MONTGOMERY COUNTY PLANNING DEPARTMENT
 THE MARYLAND-NATIONAL CAPITAL PARK AND PLANNING COMMISSION

DATE: June 1, 2007
TO: Montgomery County Planning Board
VIA: Rose Krasnow, Chief *RJK*
 Robert Kronenberg, Acting Supervisor *RJK*
 Development Review Division
FROM: Elza Hisel-McCoy, Assoc. AIA, LEED-AP *CM*
 Development Review Division
 (301) 495-2115

REVIEW TYPE: **Limited Site Plan**
PROJECT NAME: 7809 Woodmont Avenue
CASE #: 820070090
APPLYING FOR: Reduction of required setback from adjacent lot
REVIEW BASIS: Div. 59-D-3 of the Montgomery County Zoning Ordinance.

ATTACHMENT B: SITE PLAN #920070090

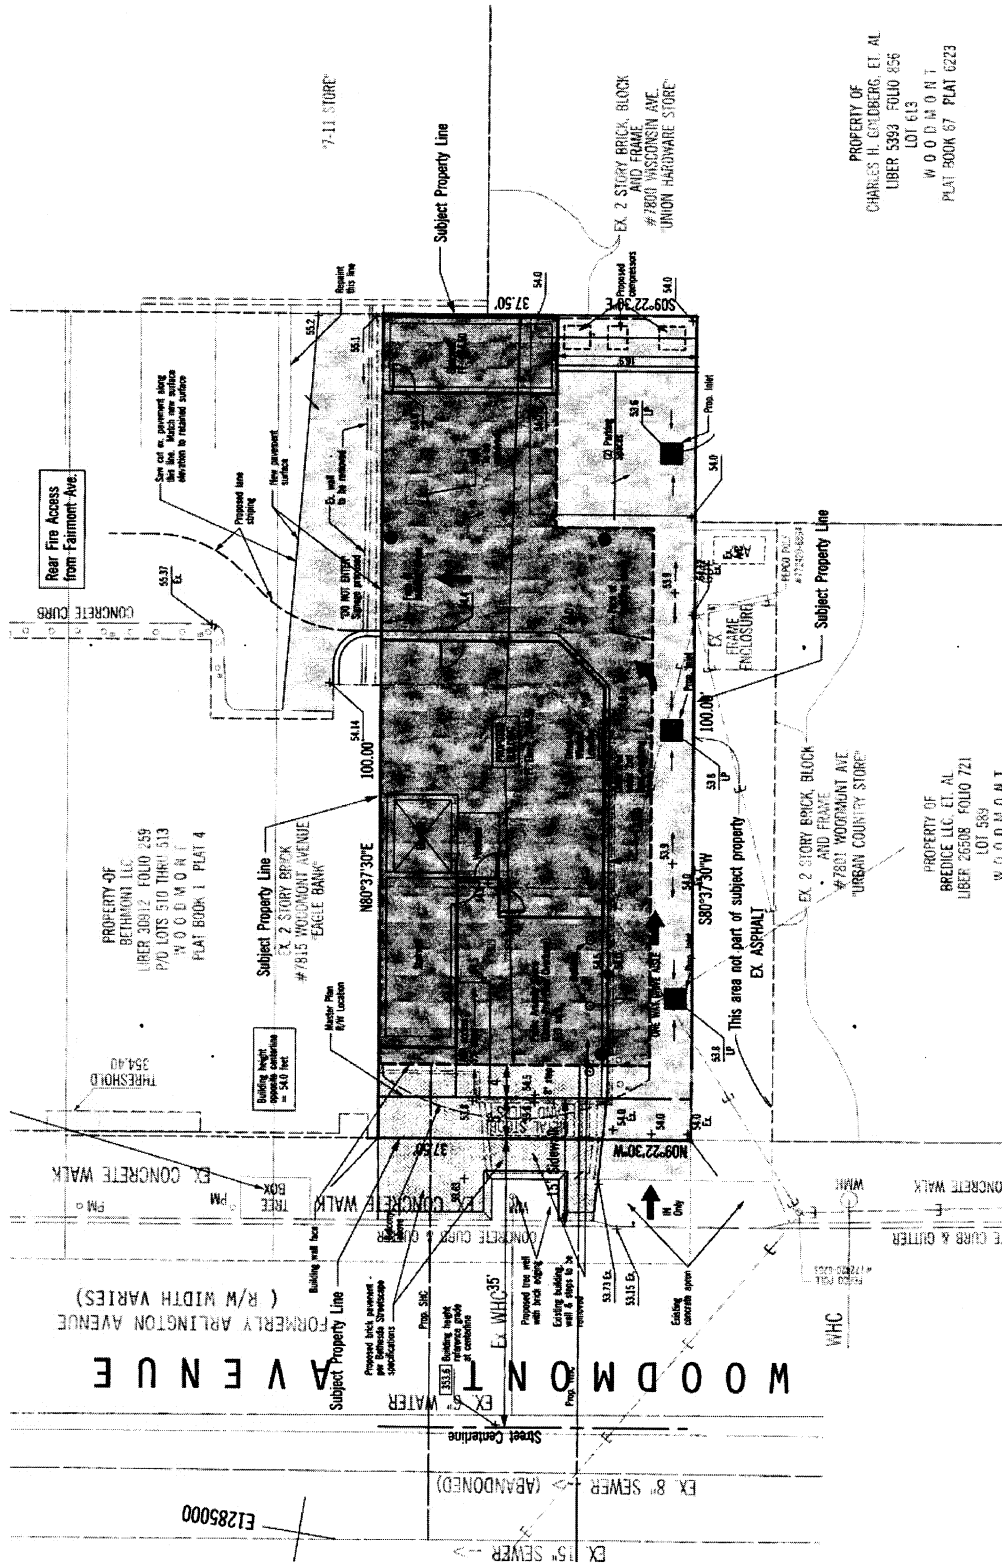
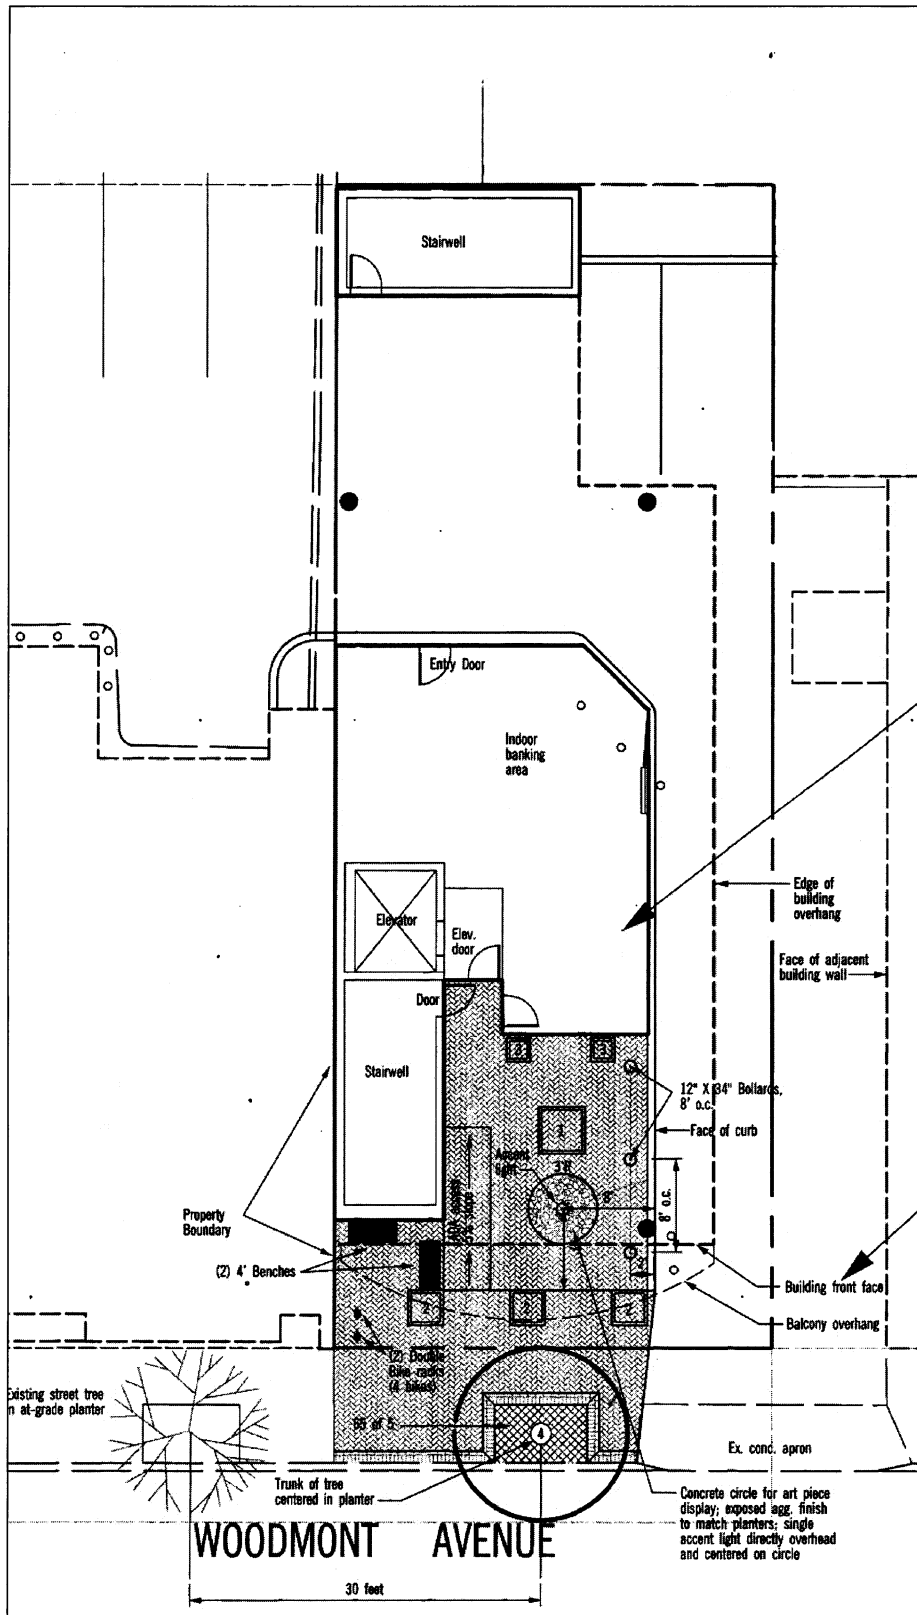
- Approve as submitted with conditions (see approval letter)
 Incomplete; recommend not scheduling for Planning Board at this time.
 Hold for additional information. See below
 Comments/Recommendations: Storm Water needs to be shown on the Site plan.
